HENDERSON COUNTY PLANNING BOARD

SUBJECT: Combined Master and Development Plan for Old Pace Major Subdivision (2007-M33)

Henderson County Planning Department Staff Report**Combined Master and Development Plan Review for Old Pace Major Subdivision (File #2007-M33)**

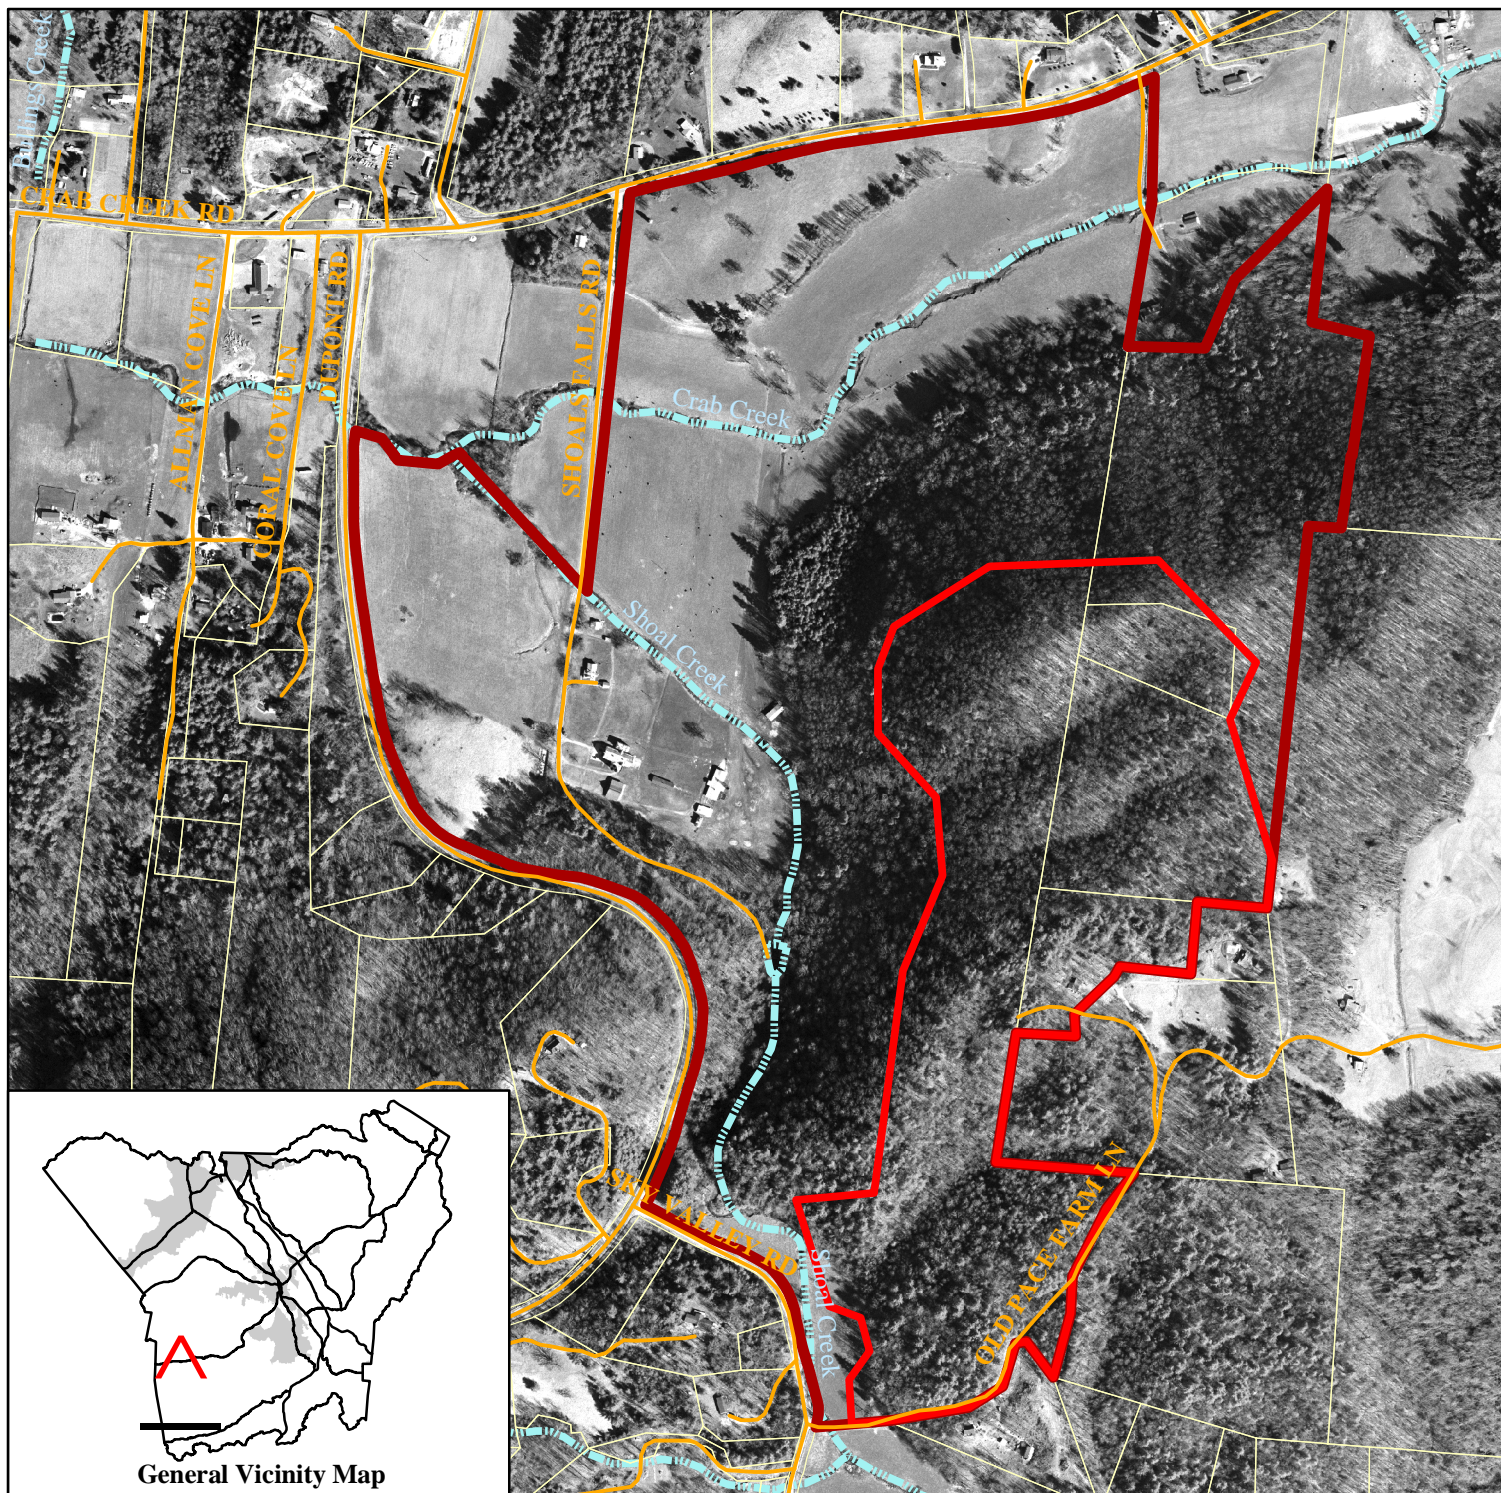
The project parcels abut Old Pace Farm Lane which has a right-of-way that does not meet the minimum width requirements of Chapter 170. According to Chapter 170, the applicant shall be required to provide additional right-of-way to conform to the standards to the maximum extent possible. The applicant is proposing, and is required, to provide up to one-half (½) of the required right-of-way measured from the centerline of the existing right-of-way (required right-of-way of 45 feet with one-half (½) of that right-of-way being 22.5 feet). As a condition of approval the applicant is required to provide the 22.5 feet of right-of-way for all portions of the project which abut one side of Old Pace Farm Lane, and 45 foot right-of-way for all portions of the project which are located on both sides of Old Pace Farm Lane.

Old Pace Farm Lane is one (1) lane (10 to 11 feet in width), is not constructed of adequate gravel/asphalt; and lacks shoulders, ditches and turnarounds (See Attachment

- 3). As a condition of approval the applicant should be required to upgrade Old Pace Farm Lane, on the portion of the road owned by the applicant, to meet the minimum standards for private local residential subdivision roads. The Planning Board should, as a condition of approval, require that the applicant submit a revised Combined Master and Development Plan to Staff showing the appropriate cross section for Old Pace Farm Lane (private local residential subdivision roads).

BRIDGE ELEVATION

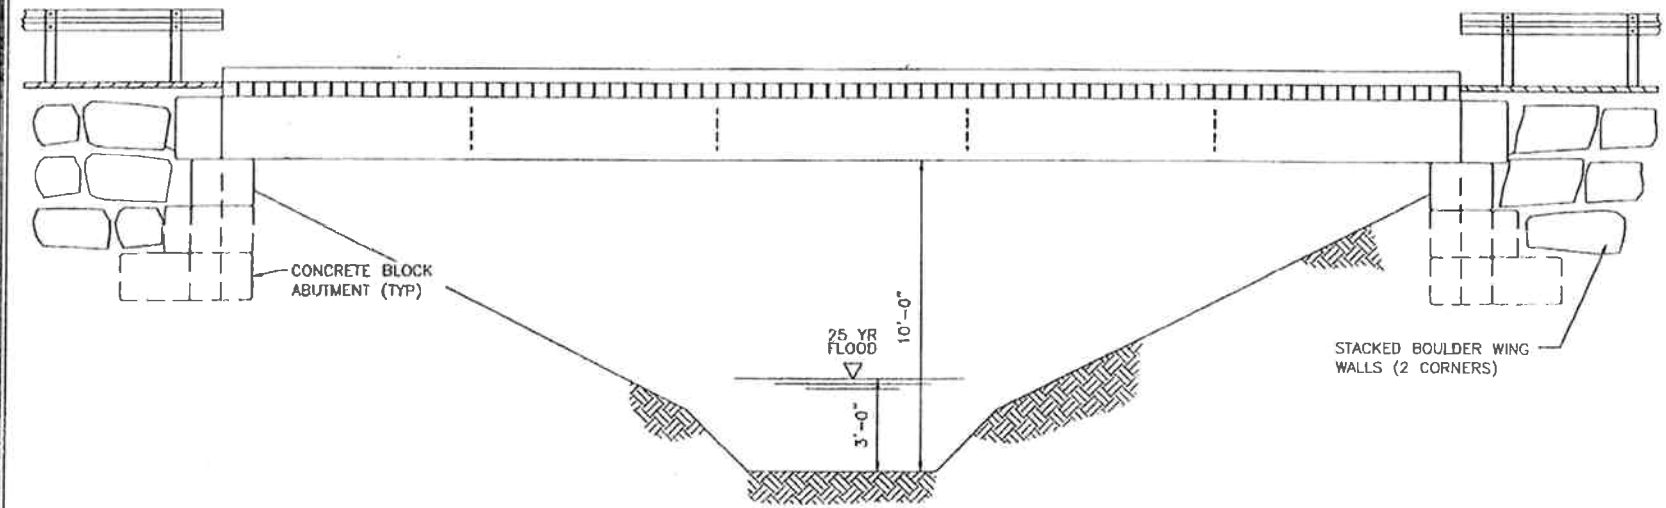
8. **Bridges.** The applicant is proposing a bridge on Ridge Pines Road, over the unnamed tributary to Shoal Creek. The applicant has submitted bridge plans showing certification from a registered professional engineer indicating that the bridge plans meet state road standards for public road bridges for drainage, hydraulics, minimum live load and vertical clearance. The travelway width across the bridge is proposed to be 18 feet. According to HCSO §170-21I(2) the applicant must submit a copy of an as-built drawing of the bridge with certification from a registered professional engineer that the bridge meets the standards required in this subsection prior to final plat approval or release of any improvement guarantee.

Bridges – Bridges must be constructed to support 35,000 pounds per axle for fire apparatus.

1 L2 TYPICAL INTERSECTION
 SCALE: NOT TO SCALE

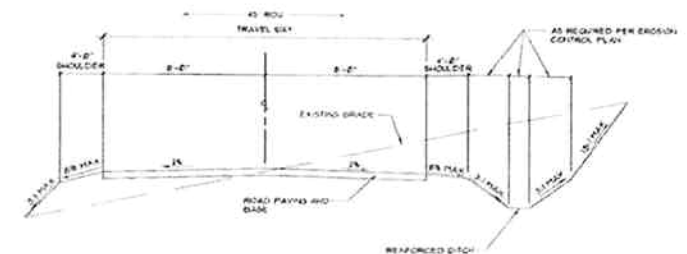
5. **Road Intersections.** Design and subsequent construction of private roads shall be reviewed by the Planning Board based on the standards and requirements of NCDOT (HCSO §170-21(C)4). According to “Subdivision Roads Minimum Construction Standards” the most desirable intersections are those with angles of 75 to 90 degrees but that intersections with angles from 60 to 75 degrees are acceptable under extreme conditions. The applicant appears to be proposing intersections which meet the “Subdivision Roads Minimum Construction Standards”.

2 L2 TYPICAL ROAD SECTION 16'-0" ROADWAY
 SCALE: NOT TO SCALE

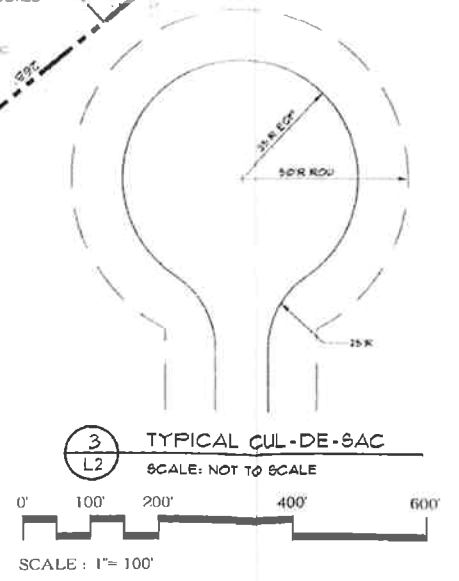
3. **Private Road Standards.** The Applicant has provided a cross section for the proposed roads (Ridge Pines Road and Valley Oaks Road). This cross section indicates that these are to be “local roads.” All subdivision roads must be designed and constructed to the minimum standards of HCSO §170-21 (Table 1).
